STATE APPROVAL REQUIRED,
REPLACEMENT SYSTEM VARIANCE REQUEST

Town of AUGUSTA

System's Location: YOUNG RD. TOGUS POND AUGUSTA ME

Subject: Approval, Replacement System Variance Request, Taylor property, Young Road, Togus Pond, Augusta

SUBSURFACE WASTEWATER DISPOSAL PLAN

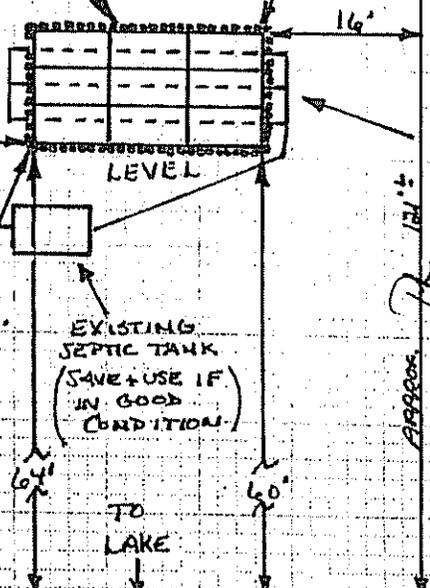
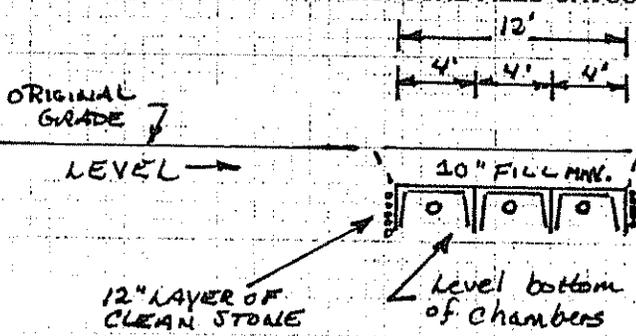
The Division has reviewed a Replacement System Variance Request for the subject property. The proposal is to install a replacement septic system for a two-bedroom dwelling. The state variance requested is to allow the installation of the system with a setback distance reduction from the owner's well to the disposal field of 30 feet. Other variances required are setback distance reductions from a neighbor's well to the disposal field of 90 feet; a major watercourse to the disposal field of 60 feet; and a full basement to the disposal field of 12 feet. The system design, prepared by John Lord Jr., SE, dated August 4, 2002, is found to be in compliance with the Maine Subsurface Wastewater Disposal Rules.

We approve the requested variances with the following requirements:

1. A permit for system installation is to be obtained from the Local Plumbing Inspector in advance of the start of system construction.
2. The system is to be installed in accordance with the submitted and approved system design. Should alterations be required at the time of system installation, the system designer must be notified prior to making any changes.
